CMD 25-H2.67

**Written Submission from
Dr. Sunil Nijhawan**

Application to renew power reactor
operating licence for the Darlington
Nuclear Generating Station

My REVISED technically based objections to extending Darlington NGS operating license by any more than 3 years are based on its utter failure in successfully mitigating severe accidents, thus putting the most populous province in my beloved country at great risk.

Figure 1 : Lower than core placement of pressurizer that will drain boiler tube inventory at Darlington reactors in a station blackout scenario (not a low frequency event)

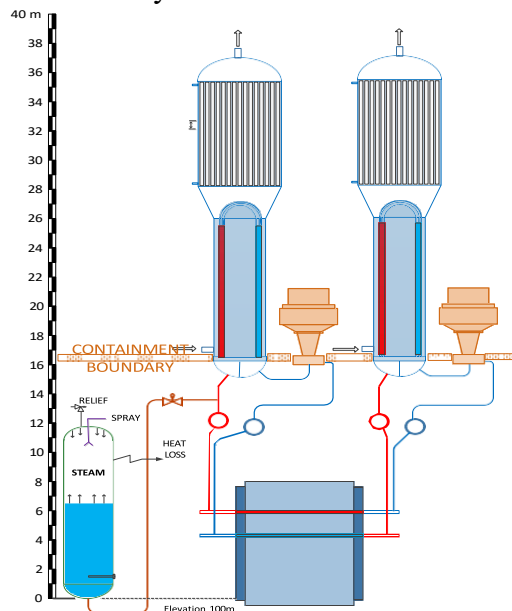
The strange choice of pressurizer location below the boilers and reactor headers (in 12 reactor units at Darlington and Bruce stations) will cause draining into it of primary coolant from boiler tubes in a SBO to an extent that boilers will become useless as heat sinks and no amount of emergency measures to add water to boilers will restore cooling to the reactor core unless the primary cooling system was replenished as well, something that cannot be done after an SBO in the present design and presently configured SAMGs.

3. Emergency power hookups to pressurizer heaters for early re-establishment of pressure control, or Relocate pressurizer to higher elevation
4. High pressure makeup of PHTS inventory loss (high pressure emergency water injection pumps)

Figure 2: Oxidation kinetics for Zircaloy, carbon steel and stainless steel

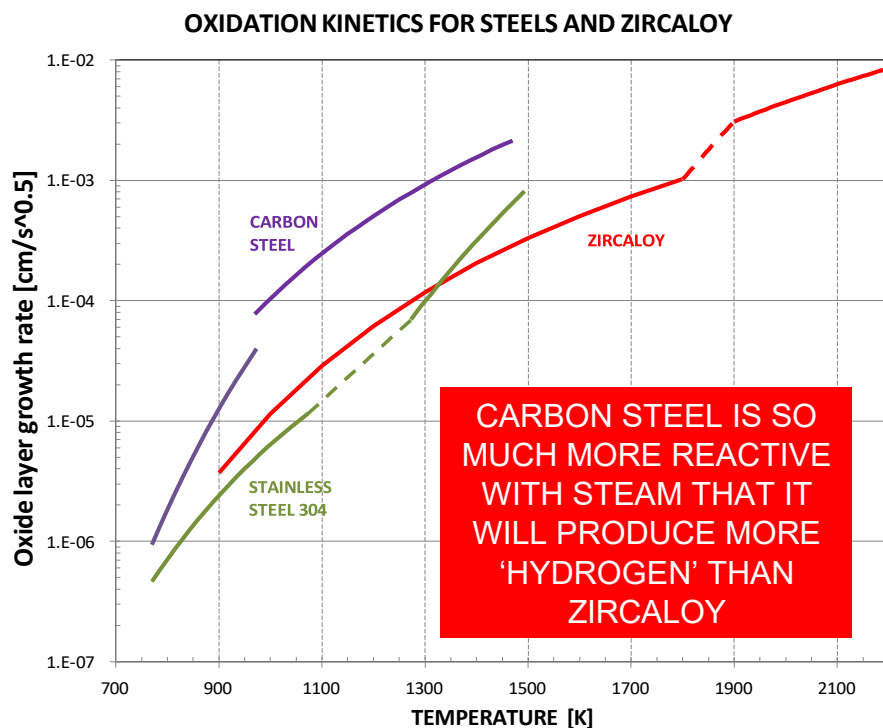
Potential for steam and air oxidation to produce copious amounts of combustible Deuterium and Hydrogen from the large amount of Zircaloy and carbon steel associated with the fuel channels during a severe core damage accident is easy to see. There is about 50,000 kg of Zircaloy with an oxidation surface area of over 12000 m² and over 120 tons of low carbon steel piping over 10 km long with a surface area greater than 1800 m² in a Darlington CANDU PHWR associated with fuel channels where a loss of cooling can elevate fuel temperatures such that rate of oxidation of feeder carbon steel will always be greater than that for Zircaloy (Figure 2) and the amount of Deuterium produced by oxidation of steel will exceed that from Zircaloy very early (Figure 3).

Figure 5: Calandria vessel, a stepped stainless steel vessel with welded annular plate

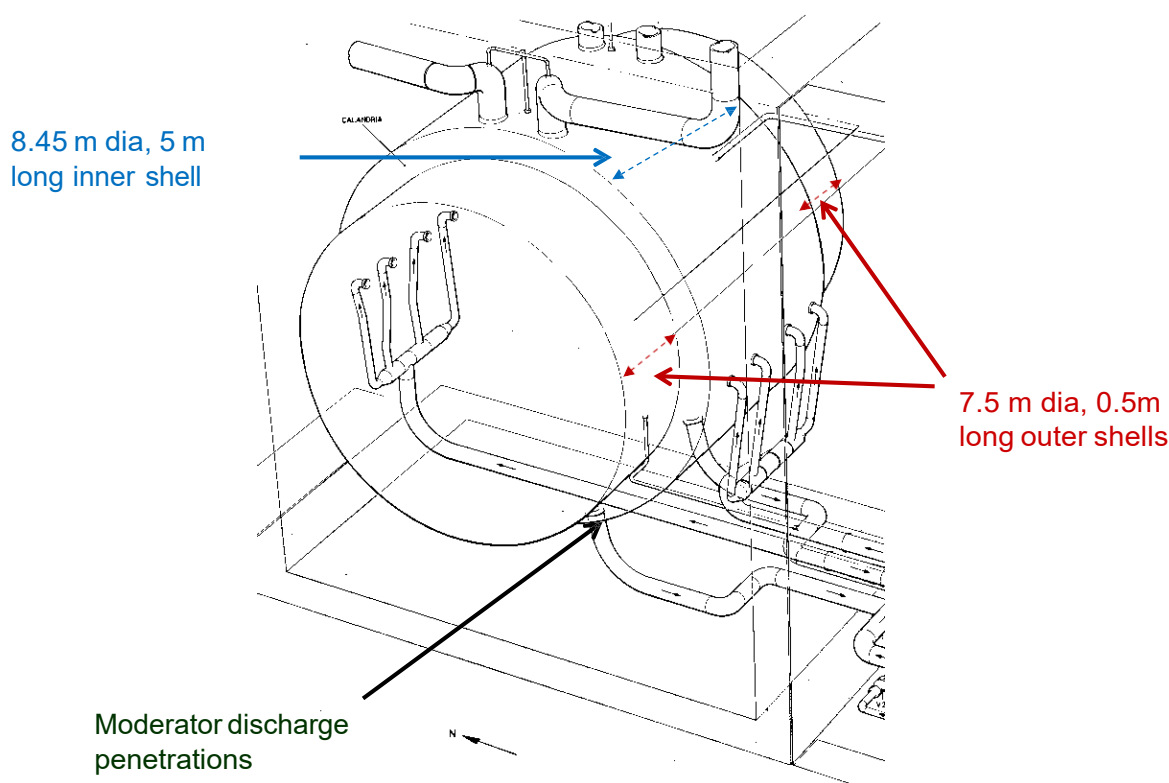
Accident termination by retention of molten core debris in a vessel have been adopted from PWRs without consideration of the design specifics of the stepped low pressure and thin CANDU moderator vessel. The debris formation in a CANDU reactor is in solid chunks of fuel channel and its eventual retention upon Zircaloy melting in the Calandria vessel cannot be guaranteed as the relatively thin walled stepped and welded vessel (wall thickness varying between 19 and 28 mm) may fail at welds by thermal loads long before any gross melting thus violently introducing water from the shield tank onto hot debris.

Any claims of an LWR like in-vessel retention of molten uranium debris are not credible or consistent with the gradual core disassembly of CANDU cores in case of a station blackout scenario with a sustained absence of heat sinks. The Calandria vessel has a wall thickness that varies between 19mm at annular plates to 28 mm in main shell. The weld failure upon differential expansion of the two shells, with outer shell constrained, is easy to demonstrate (Figure 6 and Figure 7).

Figure 6 : Likely state of debris upon Calandria weld failure

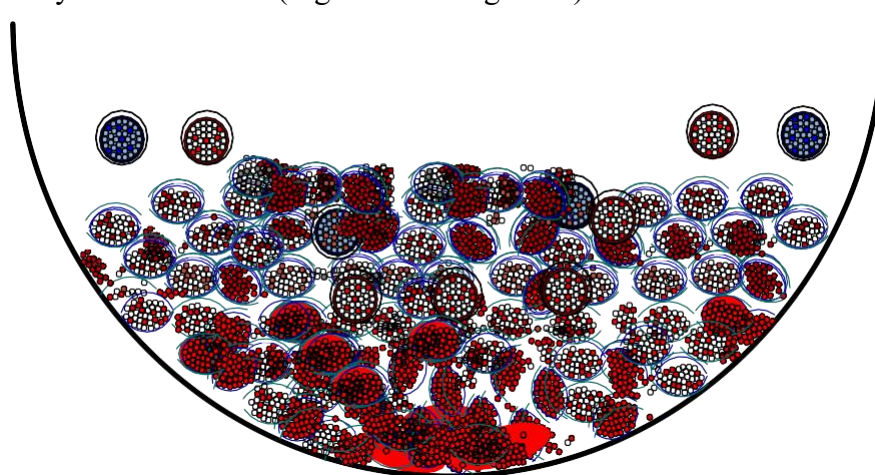
The effect of Calandria vessel weld failure can vary from additional hydrogen production, accelerated fission product releases as one mode of outcome for small weld cracks and slow leaks, to catastrophic vessel failures by energetic interactions of incoming water with the hot and molten solid-liquid debris at the bottom of the Calandria vessel as the other mode.

Figure 7: Calandria shell elongation as an indicator of stresses that will cause weld failure

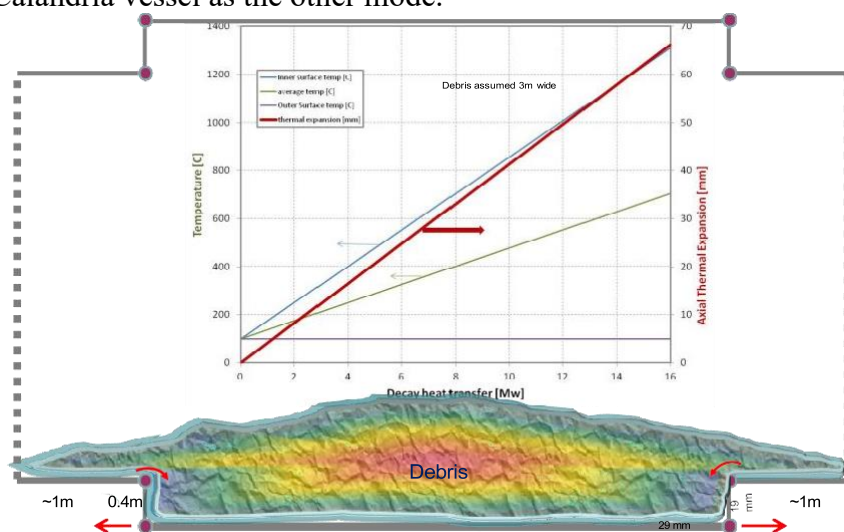
As a result of absence of a retaining vessel, direct un-attenuated releases into the containment, weak containment structures and significant likelihood of energetic interaction of hot debris with water and Deuterium burns /explosions causing challenges to containment integrity, large releases of radioactivity from failed containment structures are inevitable.

Figure 8: Multi unit layout at Bruce station; Darlington is similar

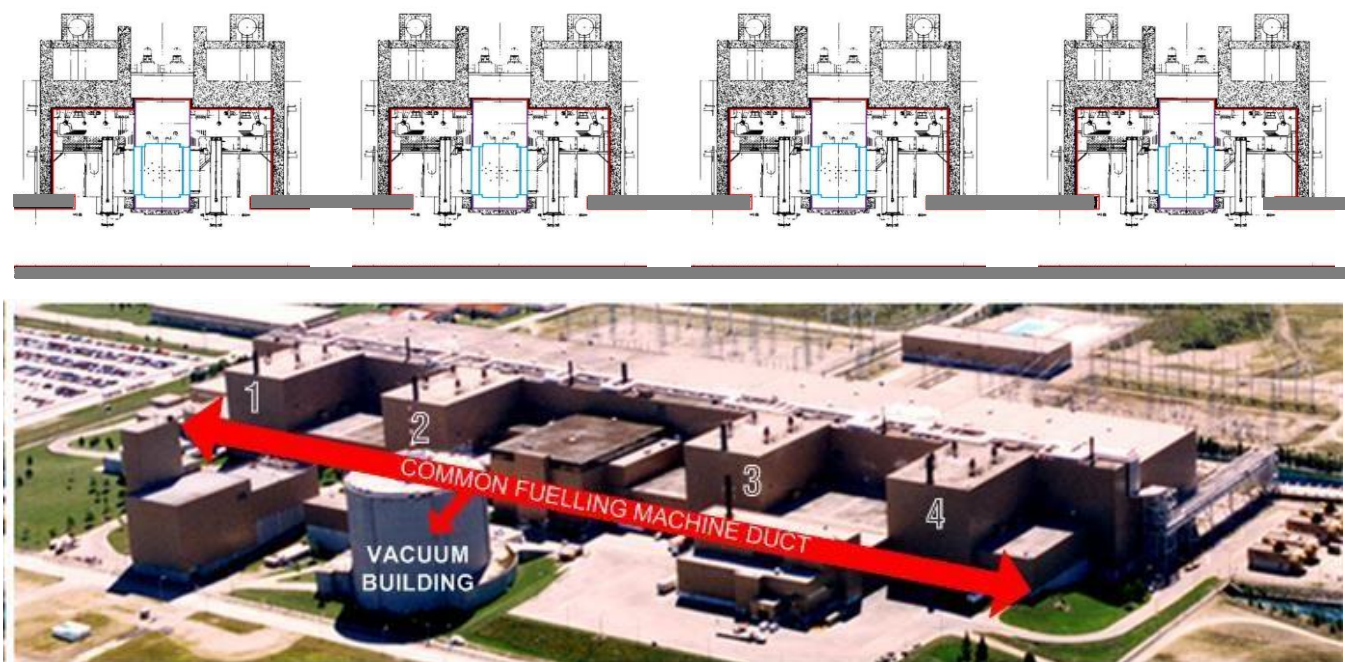
The reactor buildings around each individual reactor core are inverted cup like traps for combustible gases (Figure 8). A large number of safety significant components like the steam generators, pumps and the reactivity control devices are all outside the containment envelope and vulnerable to failures by external impact or otherwise of the weak structures on top of the reactivity decks. These are some of the vulnerabilities that can be fixed.

Figure 9: Single unit reactor assembly in a crowded vault with common fuelling machine duct below

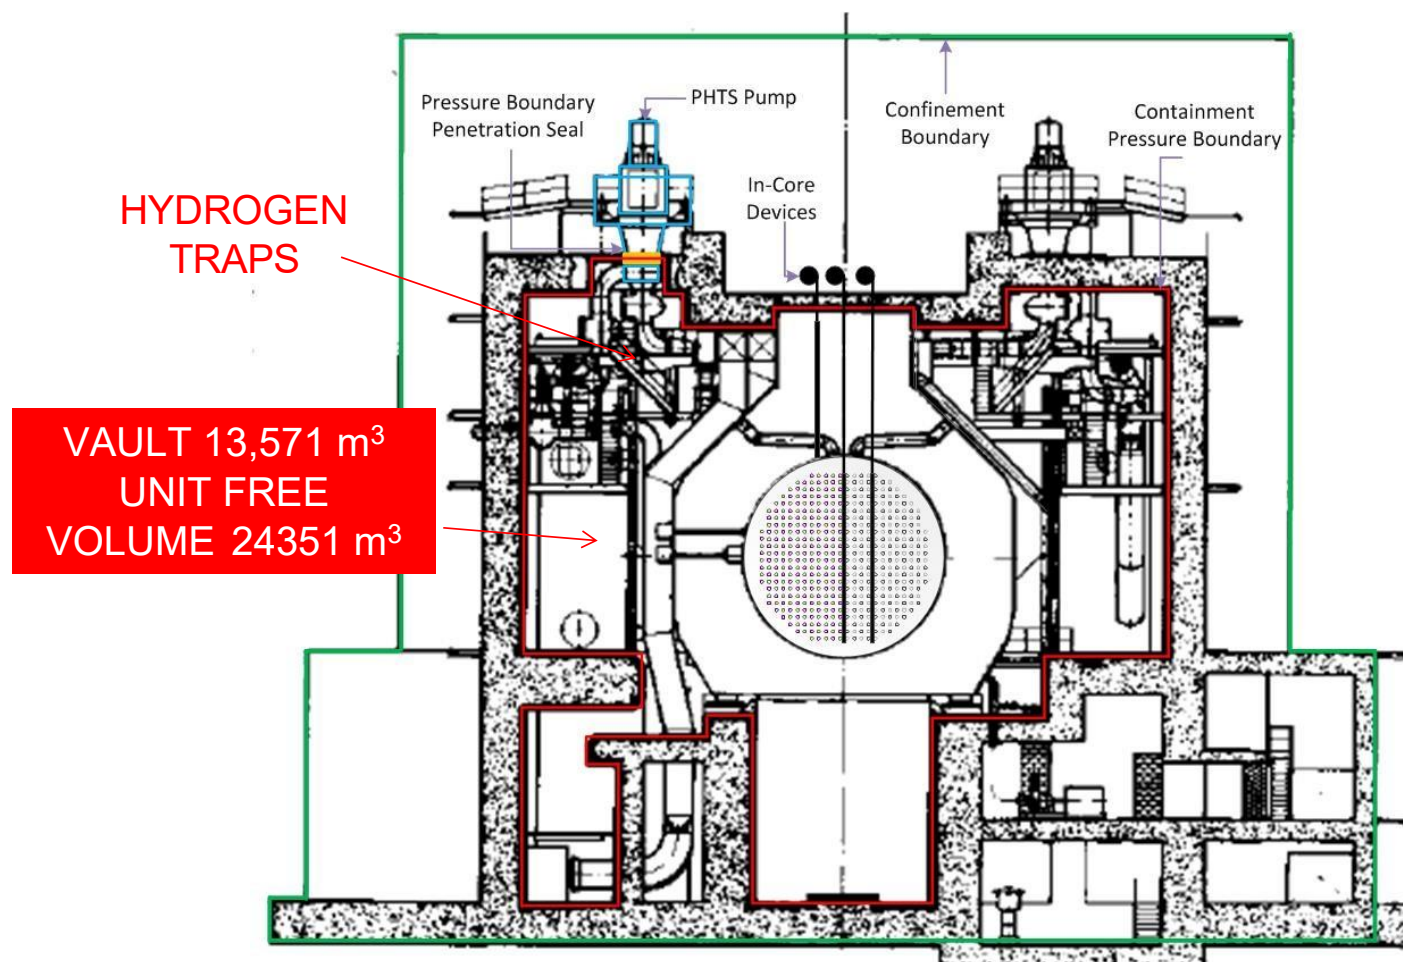
The containment layout is such that even a 1% oxidation of any of these materials will cause stagnated and explosive pockets of combustible Deuterium and Hydrogen in reactor vaults shaped like interconnected inverted cups. The reactor vault is the direct recipient of products of reaction with hot fuel as the moderator relief pipes vent into the reactor vault.

The production of combustible Deuterium gas from over ten km of carbon steel piping and over 50 tons of Zircaloy in each Darlington unit can be extremely high with steel oxidation more problematic over the longer term; making the installed numbers and types of PARS not only inadequate but as early ignition sources also dangerous.

Figure 10 : Darlington station layout for 4 units with common containment

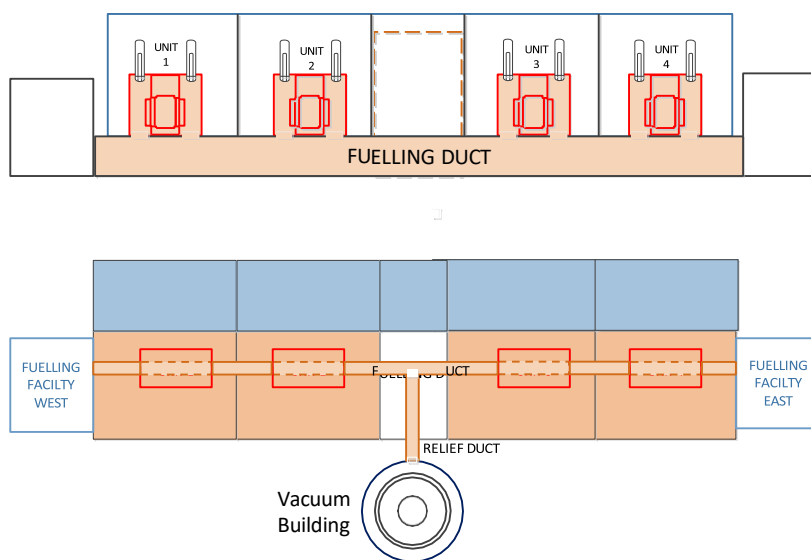
common and contiguous to 4 relatively large reactor power units. Each reactor is capable of putting un-attenuated fission products from the ~2700 MW(th) fuel fission sources as well as combustible Deuterium from over 50,000 kg of Zircaloy and 2000 m² of the 120,000 kg of carbon steel. As a result, any accident that results in activity releases into the containment, whether within the design basis or not, is likely to contaminate and disable from service all four reactor units.

With an over pressure retention capability of less than a bar (at design and significantly deteriorated after 20+ years such that all containments are no longer tested at design pressure or at the required frequency of 6 years) and a containment structure made up of rectangular concrete slabs and about 500 times leakier than the 1%/day leakage at design pressure for PWRs, a number of critical equipment are outside the containment and some critical equipment like pressurizers are placed below the mid elevation of the reactor core inside the containment. A common Fuelling Machine Duct underlying the 4 reactors connects the containment volume via a Pressure Relief Duct to a Vacuum building whose volume is deemed adequate for most design basis accidents in a single unit but its effectiveness to mitigate a severe accident in all 4 units is very obviously lacking as the effective volume per reactor unit is less than half of that for a typical PWR and the structures are weaker and with greater likelihood of trapping combustible gases. The containment is built to the National Building Code as are the access requirements, fire protection, smoke detection, etc. It is not built to modern nuclear containment standards.

Figure 11 : Building basement layout below Lake water level. The emergency power supply generators are at grade level with cable tunnel 6m under.

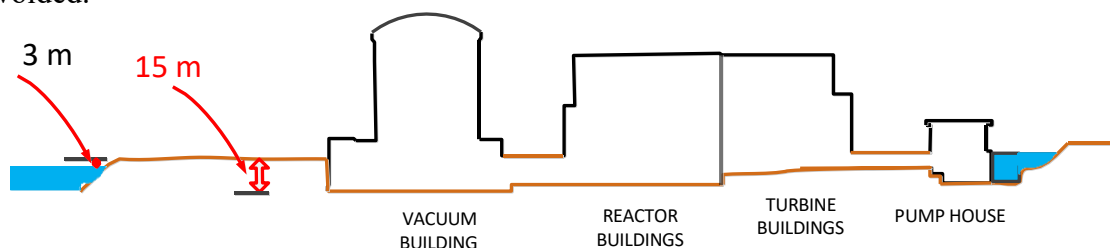
The basement of the reactor buildings (fuelling machine duct and the pressure relief duct) is located below the level of the water in the lake. To the credit of the utilities, new portable Emergency Diesel Generators have been to be located at elevations higher than the original backup Diesel Generators that are at lower grade elevations, about 3m higher than the water, not dissimilar to what sank Fukushima. They are yet to be relocated to higher elevations. If that was done a failure similar to that at Fukushima could be avoided.

Figure 12 : Comparison of a PWR containment design pressure leakage with that for a Multi unit CANDU.

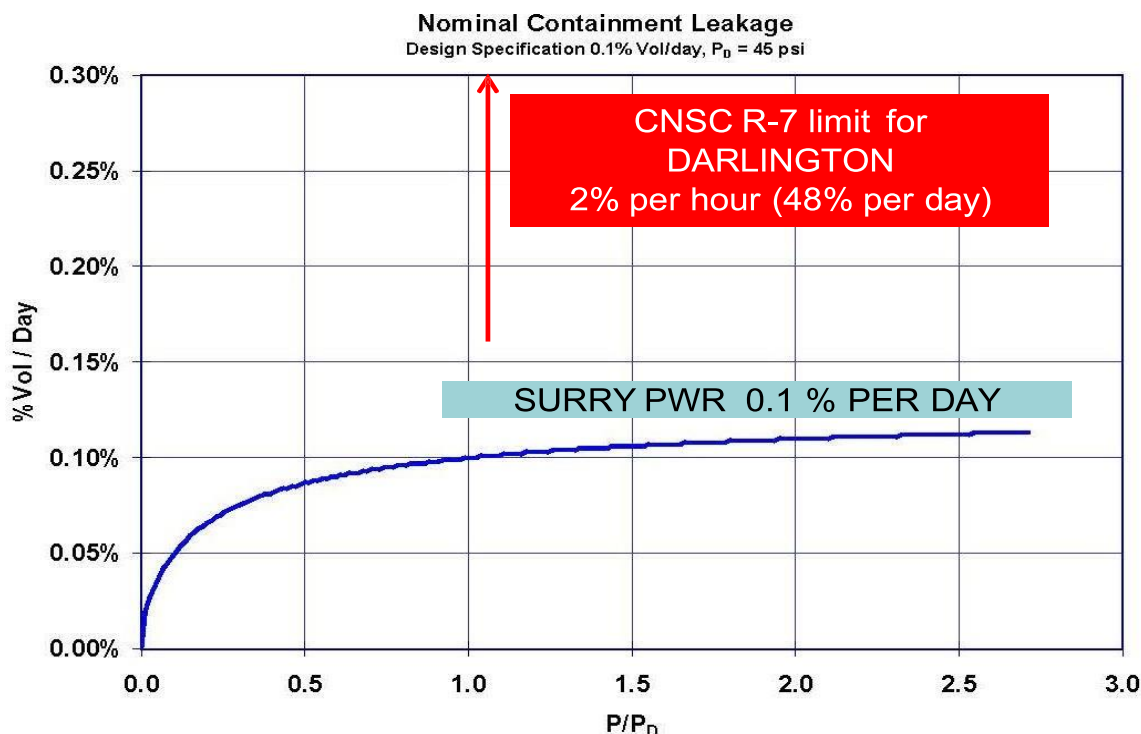
The containments are tested for pressure retention most infrequently of any power reactor in the world. Darlington now tests containment for pressure every 12 years while the regulations under which it was originally licensed required a 6 year test interval. The last pressure test was described as a difficult and arduous process that took 6 months of planning.

Figure 13: Spent fuel bundles stacked like fish in a fish basket, 16 or more trays high

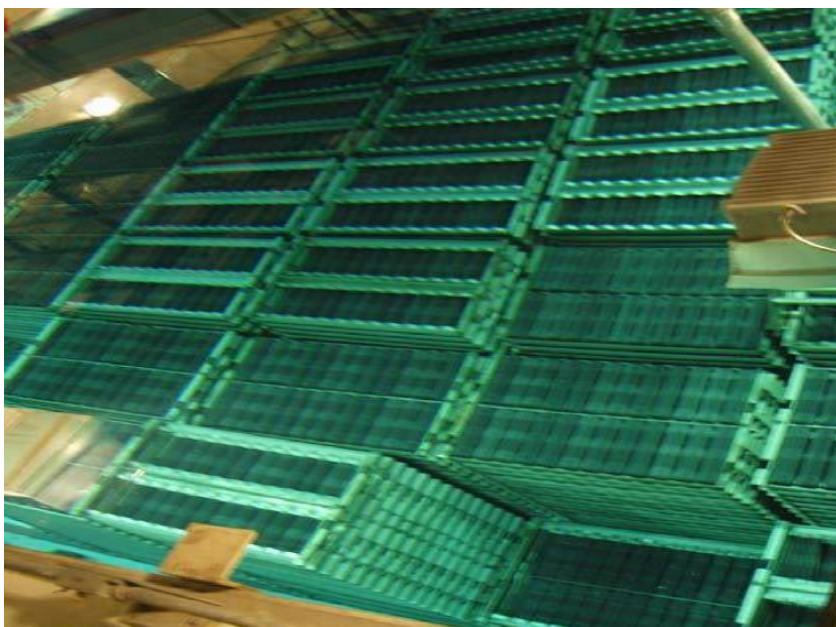
The spent fuel medium term storage in spent fuel pools is poorly designed and highly susceptible to Zircaloy fires.

17. External water makeup to a stranded fuelling machine after a LOCA
18. External water makeup and heat removal from the spent fuel bay
19. Off-site measurements of activity magnitude and energy for identification of radioactive species in releases and correlating them to source terms;
